RECOMMENDED SERVICE BULLETIN

RSB 42NG-061

Replacement of the turbocharger V-clamps.

WI-RSB 42NG-061

Figure 9

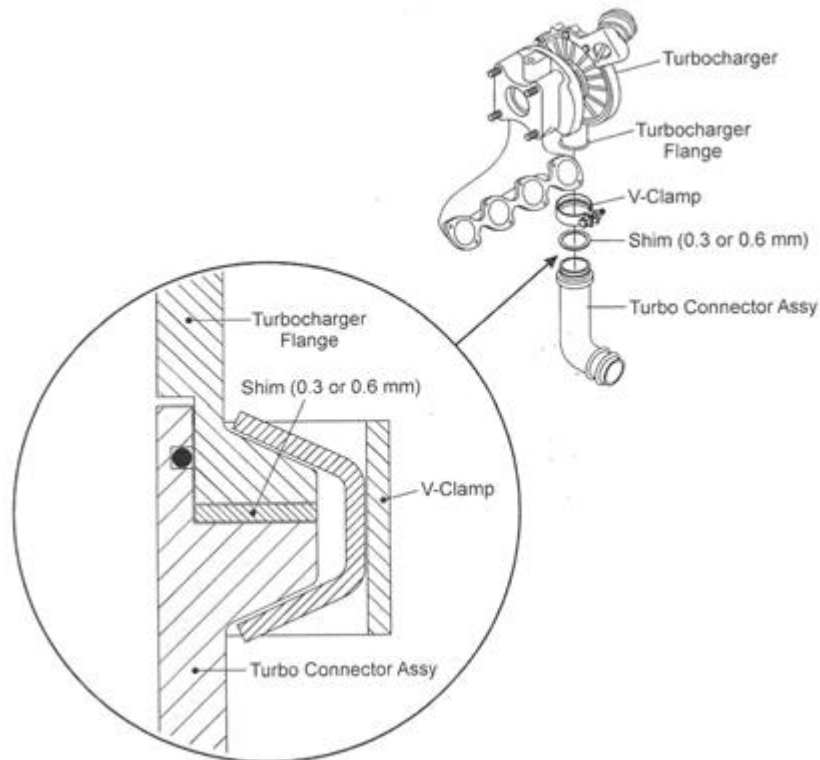
- Make sure that the distance between V-flanges on the lock is between 6 and 10 mm (refer to Figure 8). If necessary, insert turbo connector shims to obtain the required distance (refer to Figure 9).

Figure 10

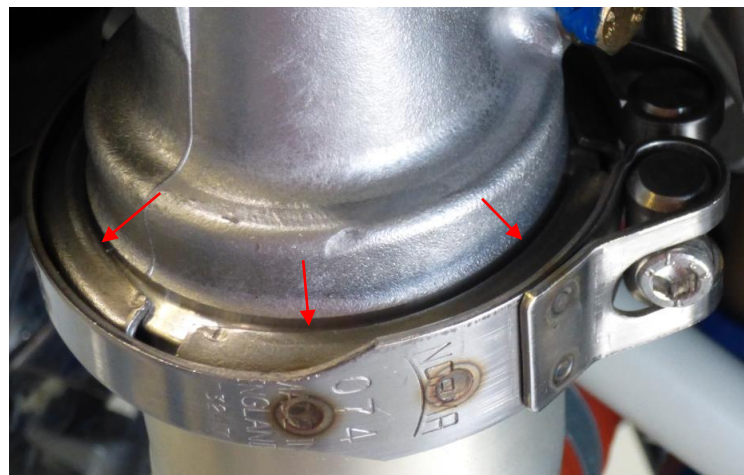
- Make sure the circumferential gap to the turbocharger is equal (if not, use rubber mallet to tap V-clamp into position). If tapping with a rubber mallet was required, retighten to 5.5 ± 0.5 Nm (4.0 ± 0.4 lbf.ft). Refer to Figure 10.
